4.1 18/03929/MMA

Proposal: Minor material amendment to 16/03186/FUL - Proposed Chapel, maintenance store, access, car parking and associated landscaping. To re-position external windows and doors. As amplified by amended Proposed Site Plan drawing received 25 April 2019.

Location: Watercrofts Wood, Old London Road, Badgers Mount, Kent

| Rev   | Date     | Comments |
|---|----------|----------|
| Title<br>Proposed Site Plan   |          |          |

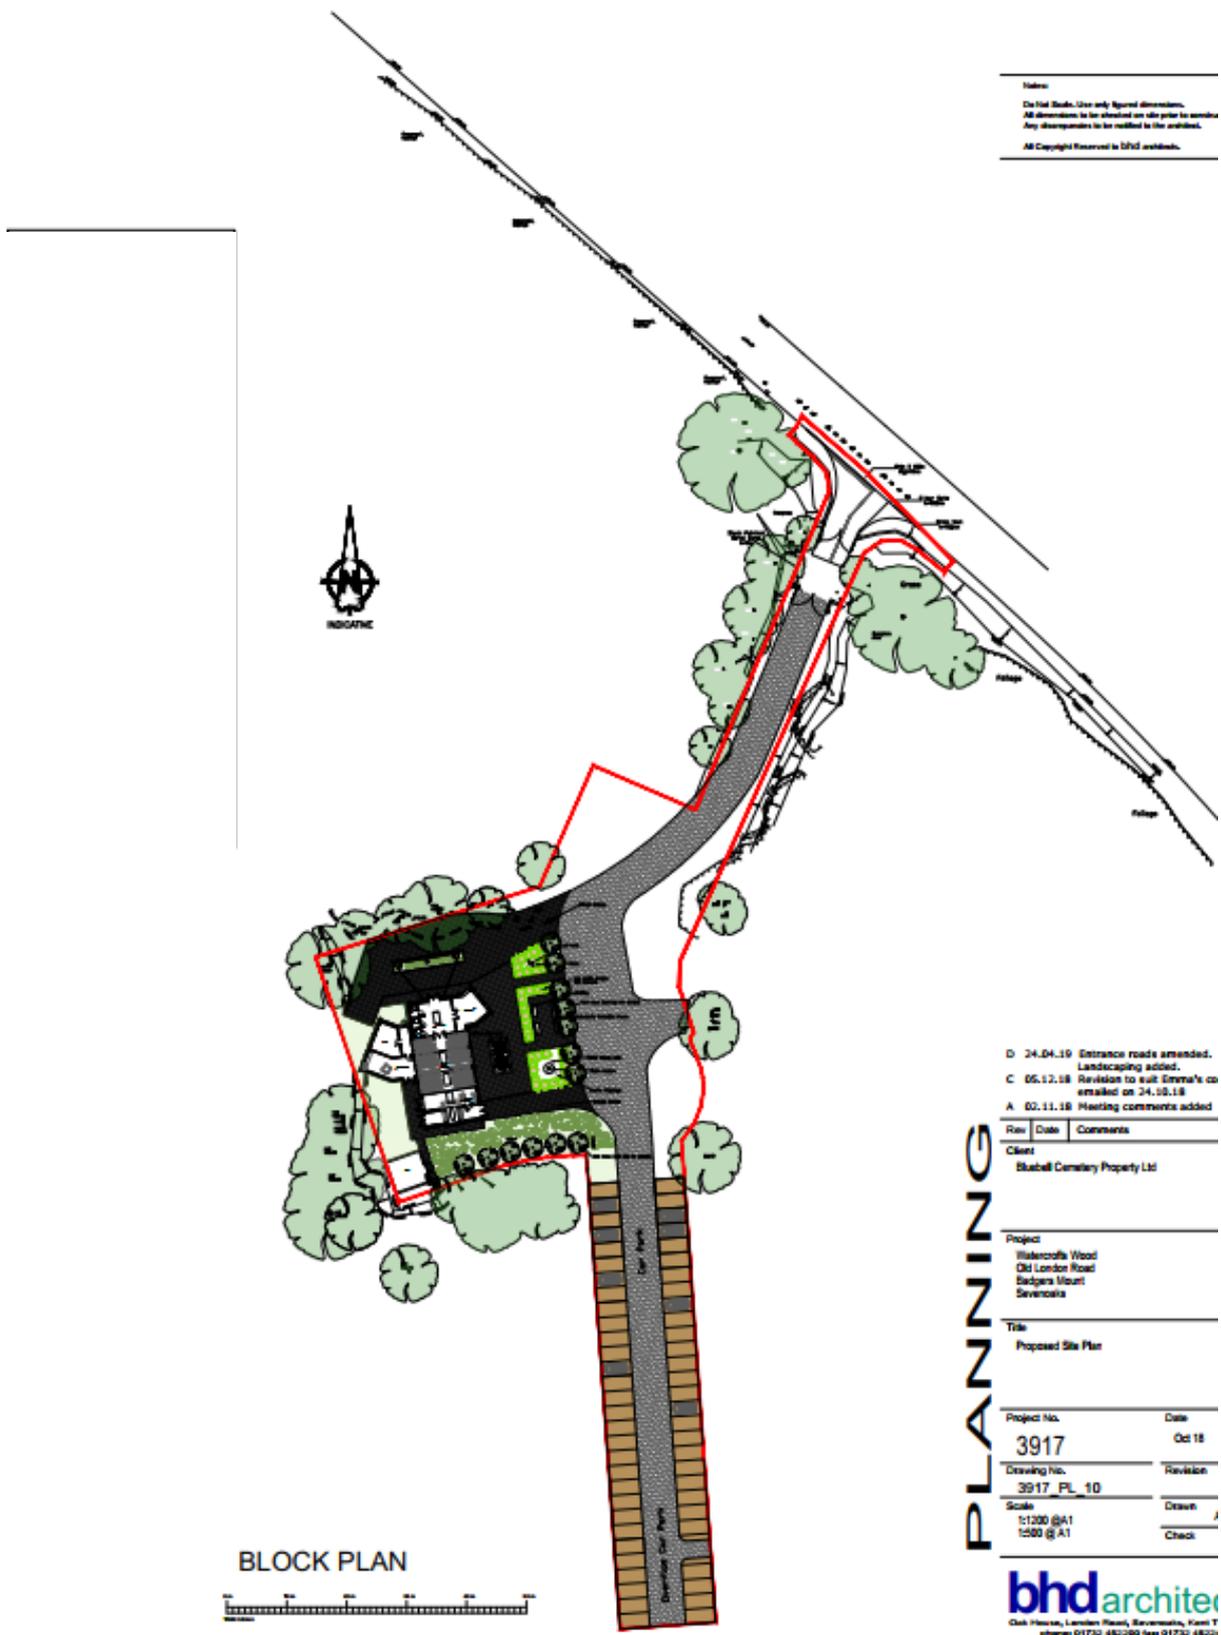
“The proposed landscaping as shown upon drawing number 3917\_PL\_10 appears acceptable. I would like to see specific details of tree species, varieties and where planted and sizes please.”

- 54 The contemporary design approach with grass roof to the chapel benefits from planning permission and thus I have no objection to the proposals in this regard. The layout and design largely follows that approved. However, more extensive hardsurfacing has been provided to the east of the chapel, with new landscaping proposed and the hearse access has been slightly extended.

- 55 Because of the raised nature of the site of the chapel relative to the land to the east and south of the site, the hardsurfacing area would not be readily visible outside the site. In my view, the key issue is whether the eastern elevation of the building would be more exposed to wider view because the small tree belt immediately to the east of the chapel has been removed contrary to the approved plans.

- 56 This does expose the site to longer distance views. However, the proposals as amended propose replacement tree planting. In my view, once

established, this planting would provide a good screen to the building and the resultant visual impact would be little different to the approved scheme. I consider it would be advantageous to require this planting to comprise established trees, so that their benefit would be more immediate. This could be adequately covered by condition.

3) Use of the building shall not commence until details of the individual tree planting indicated as part of the landscaping proposals on Proposed Site Plan drawing 3917\_PL\_10 Rev. D have been submitted to and approved in writing by the District Planning Authority, such details to specify the siting, species and size of planting. The details should also include a scheme of tree planting to the east of the access road opposite the chapel and adjacent to the proposed turning head. Such details to also include details of ecological enhancements as recommended in the Landscape Planning Ltd. Preliminary Ecological Appraisal approved under application reference 16/03186/FUL. In all other respects the hard and soft landscaping shall be implemented in accordance with the details indicated on the Proposed Site Plan. All soft landscaping and ecological enhancements shall be completed/planted during the first planting season following practical completion of the development hereby approved. The landscaping and tree planting shall have a two year maintenance/watering provision following planting and any existing tree shown to be retained or trees or shrubs to be planted as part of the approved
